**SAN ANTONIO WATER SYSTEM
DSP NEW WORLD TANK AND
PUMP STATION IMPROVEMENTS
SAWS Job No. 12-6114
Solicitation No. B-14-054-RA**

ADDENDUM NO. 1

August 12, 2014

Consulting Engineer: CP&Y, Inc.

SHEET C-21
SHEET 35 OF 91

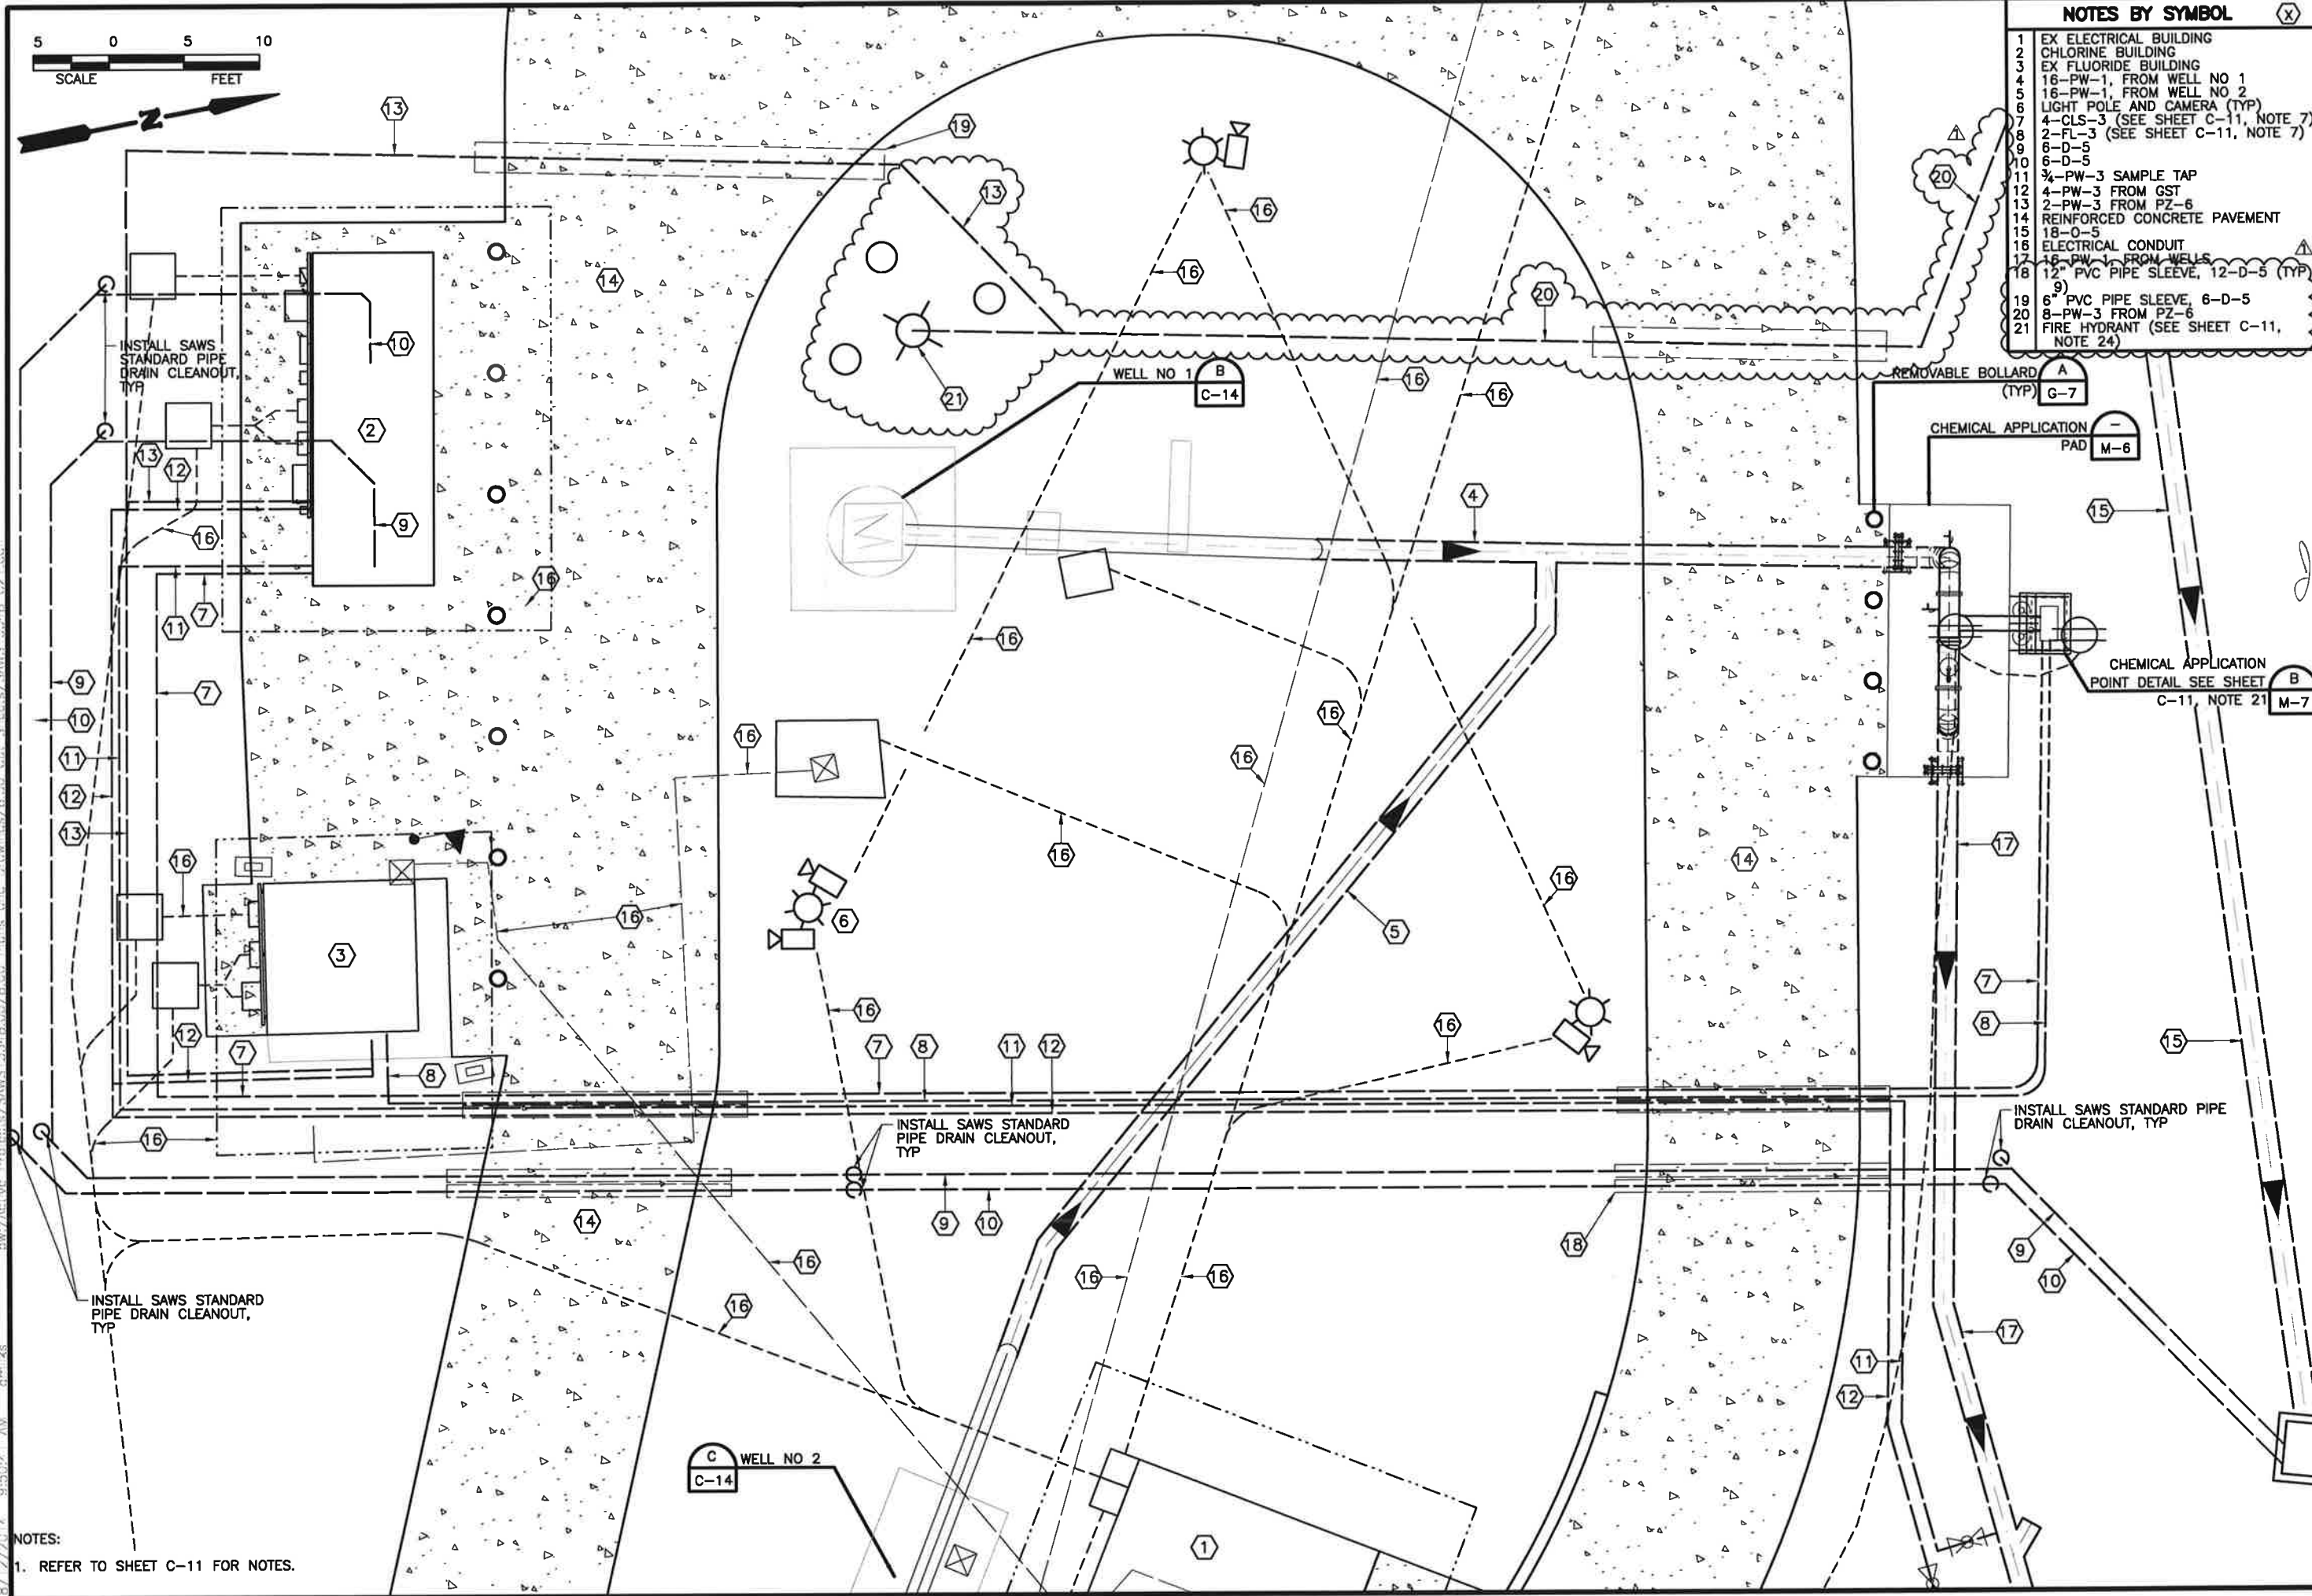
34. Question: Sheet T-3, We would recommend that flexible couplings such as a dresser coupling be installed on all under floor piping to allow for flexibility of the piping system in order to tolerate anticipated foundation settlements. The flexible couplings should be designed by the Engineer and located within 2' to 3' of the tank foundation. Please confirm that this is acceptable and required on this project.

Response: Refer to Civil Drawings (Sheet C-20) for location of flexible couplings in the yard. Should additional flexible couplings be required to accommodate the movement of the proposed tank they should be included in the tank manufacturers bid as part of the lump sum bid.

FIGURE
 2

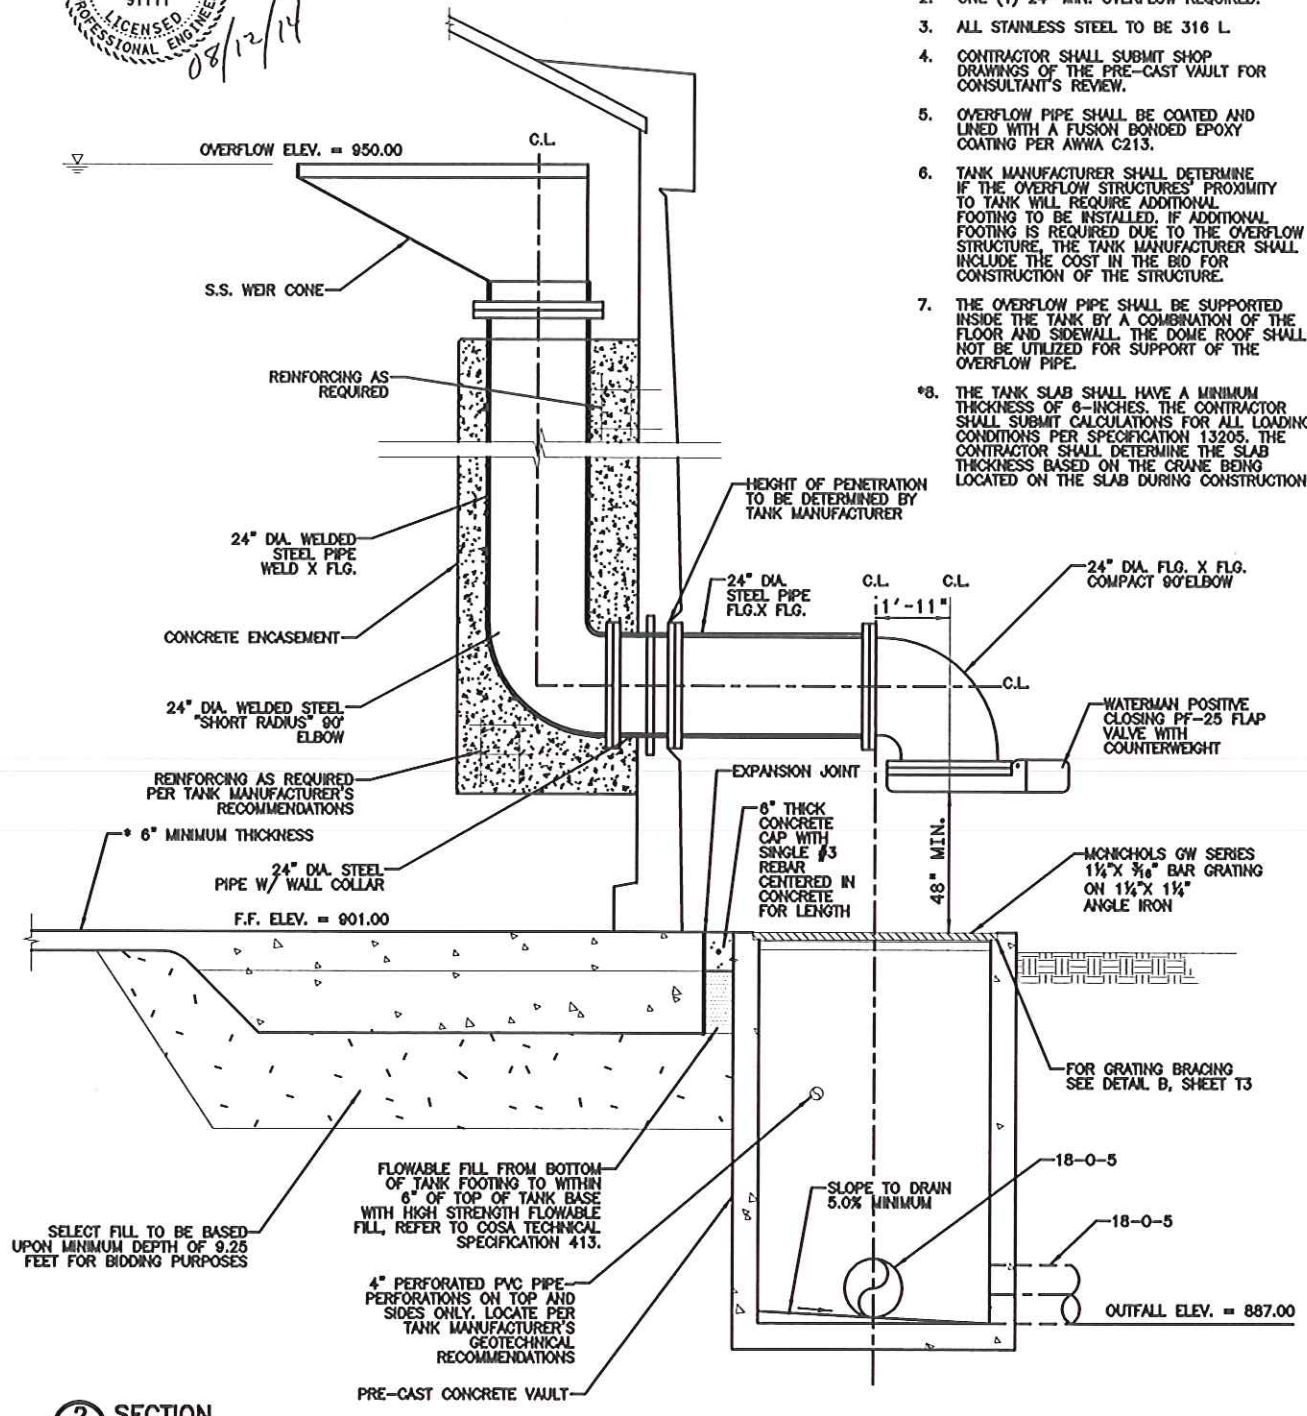
33. Sheet T-2 indicates flowable fill with a 6" thick concrete cap connecting the tank footing to the precast concrete vault structure. We recommend not connecting any structures to the tank footing to avoid any potential damage that may occur from differential settlement between the two structures. Please confirm an expansion joint or durometer pad is required between the flowable fill/6" concrete cap and tank footing.

42. Question: Section 2 on Sheet T-2 has an arrow pointed to the material below the tank floor with the text "Select fill to be based upon minimum depth of 9.25 feet for bidding purposes" The same fill material is described as "flowable fill" in the same section at a location between the overflow structure and tank footing. Please confirm the extent of flowable fill material.

Response: Sheet T-2, Detail 2 has been revised to include an expansion joint between the tank footing and the flowable fill/6" concrete cap. Refer to Item No. 67 in the Drawings section below for modifications.

Response: The flowable fill shall be installed from the bottom of the concrete cap to the bottom of the tank footing. An expansion joint shall be installed between the Ground Storage Tank footing and the flowable fill/6" concrete cap. Refer to Item No. 67 in the Drawings section below for modifications.

FIGURE
1

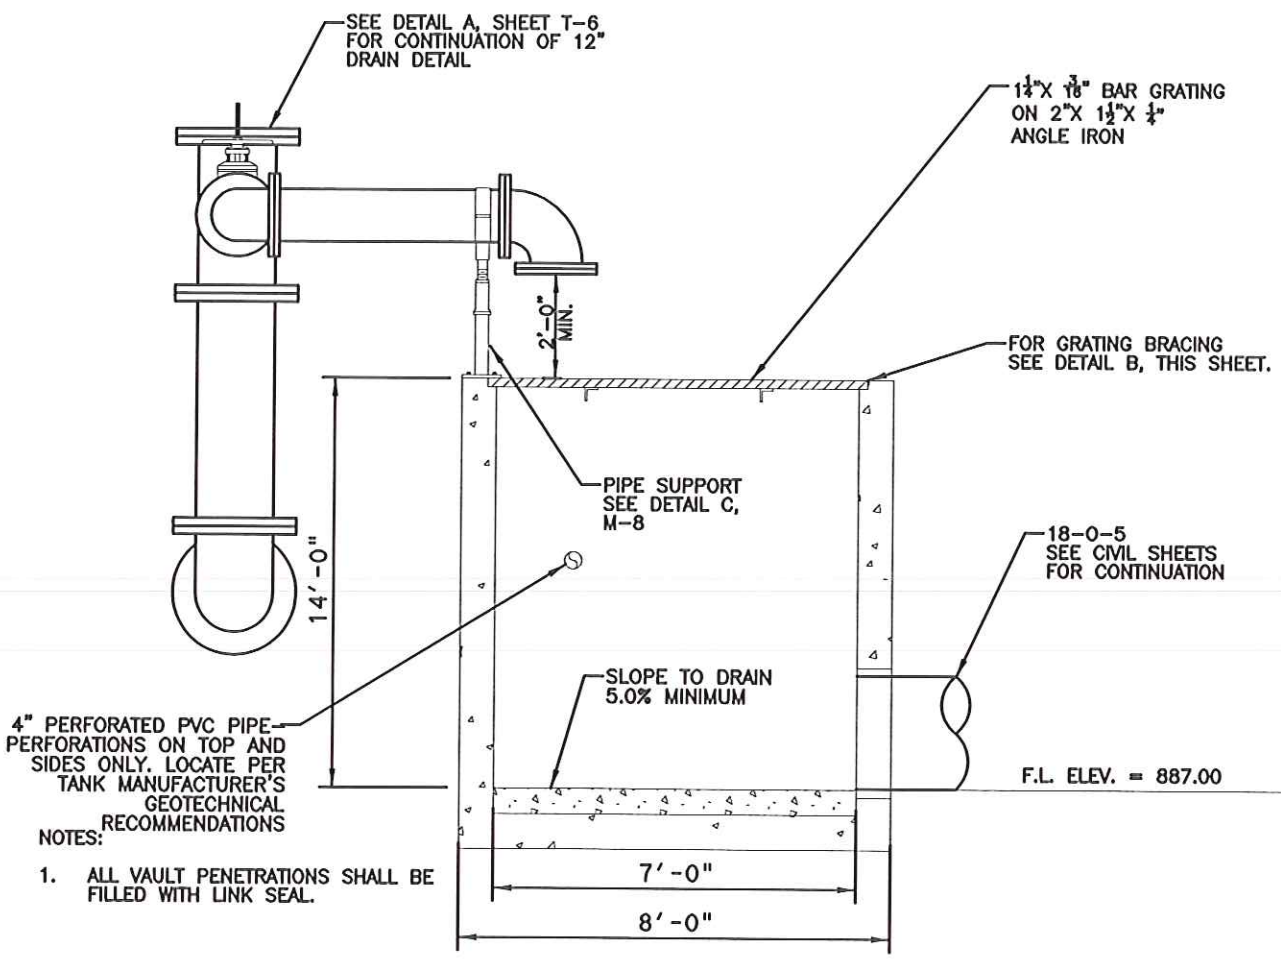
15. Question: Floor slab thickness. There is a discrepancy among the project documents regarding the floor slab thickness: Sections 13205-2.01.D and 3.02E, specify a 6” slab, while Sheet T-2, Section 2 shows 4”.

Response: The minimum slab thickness required is 6-inches. Sheet T-2, Section 2 will be updated. Refer to Item No. 67 in the Drawing section below for modifications.

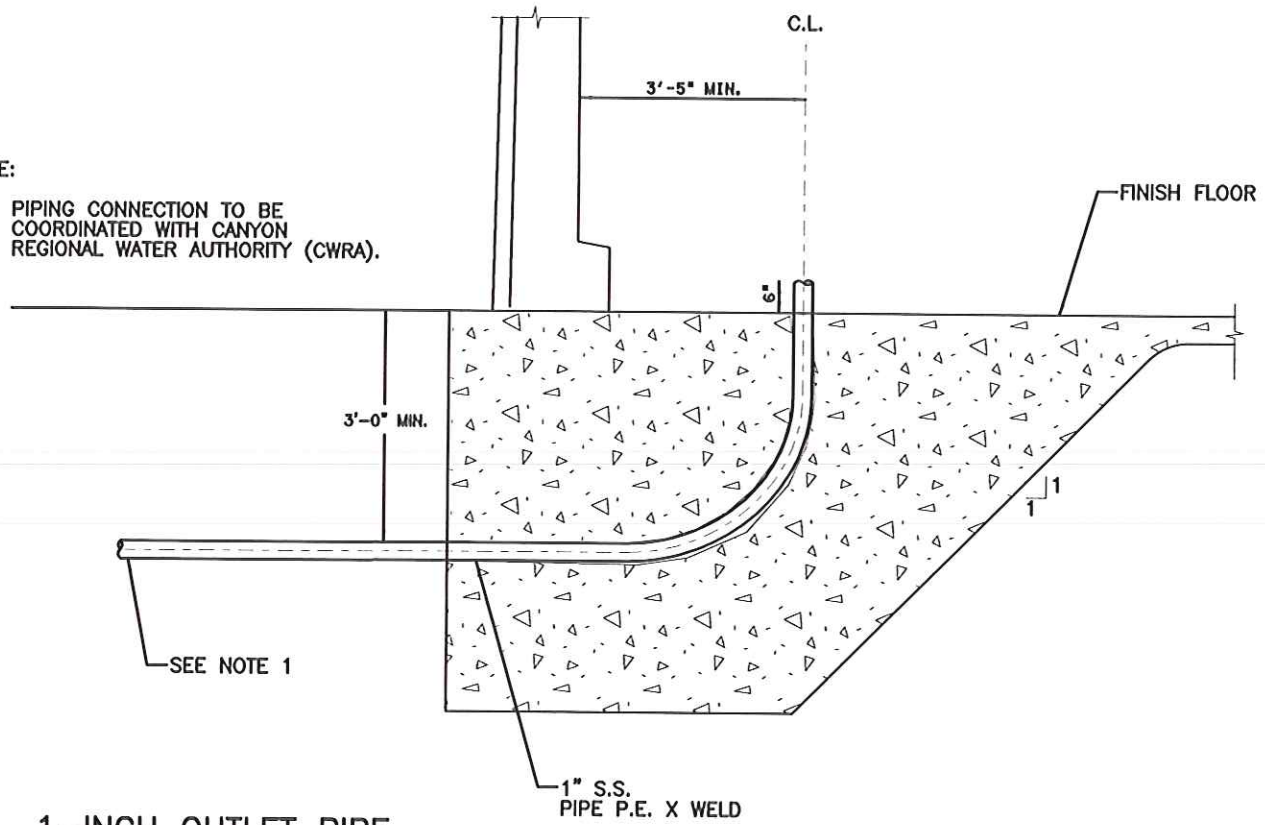
37. Question: Sheet T-7, Detail A, please provide the centerline elevation of the 1" S.S. piping through the tank foundation.

Response: The 1-inch Outlet Pipe shall have a minimum of 3-feet of cover. Refer to Item No. 71 in the Drawings section below for modifications.
